Work Order ID 134426

Item Name: Replacement Skidtube, High Gear with Standard Wearplates Fits LH or RH

DRAWING NO. D2650	TITLE 206/407 SKIDTUBE ASSEMBLIES	REV. F	DART AEROSPACE LTD ENGINEERING ORDER		D.E.O. NO. D2650-F-1	SHEET NO. SHEET 1 OF 1	SCALE NTS
DRAWN 12.10.12	CHECKED A.P. 12.10.22	MFG. APPR. 12.10.22	APPROVED 12.10.22	DE APPR. 12.10.22

CHANGE C'BORED WELDED CROSSBOLT SPACERS TO SWAGED SPACERS

DETAIL G

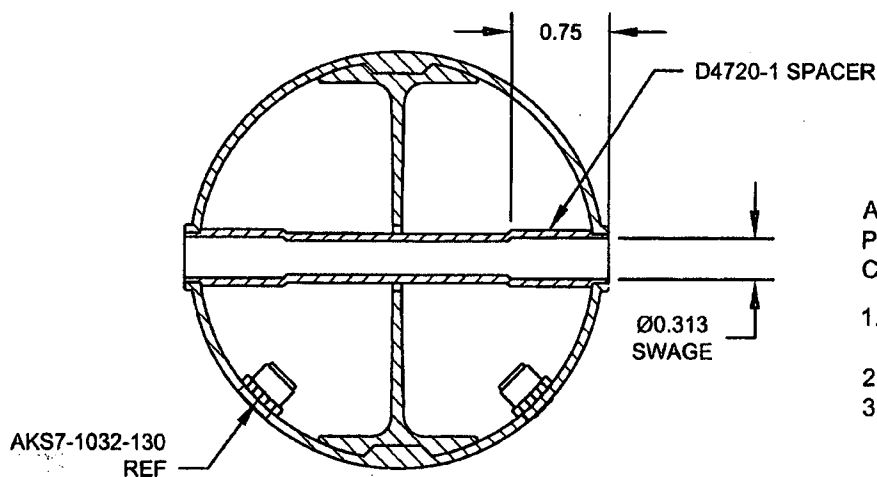
ADD DETAIL G BELOW, WHICH IS THE SAME SECTION VIEW AS DETAIL D OF DWG.
C'BORED HOLES ARE **NOW SWAGED** PER DETAIL G BELOW. FOR THE Ø0.375 HOLE THAT IS NOT C'BORED, WELD PER DETAIL D OF DWG (SEE AMENDED DETAIL B FOR REFERENCE).

AFTER DRILLING AND BENDING ASSEMBLY
PERFORM THE FOLLOWING FOR Ø0.375 HOLES THAT ARE
CURRENTLY C'BORED:

1. INSERT D4720-1 SPACER, 16 PL (-1) OR 17 PL (-3)
OR 19 PL (-5) OR 23 PL (-7)
2. SWAGE TO Ø0.313 X 0.75 DP PER QSI 002
3. TRIM / GRIND FLUSH PER QSI 002

AMENDMENT TO DETAIL B
NOT TO SCALE

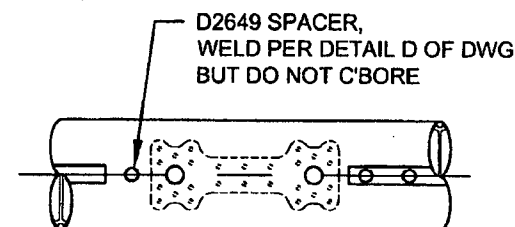
FOR HOLES THAT ARE CURRENTLY C'BORED ONLY
NOT TO SCALE
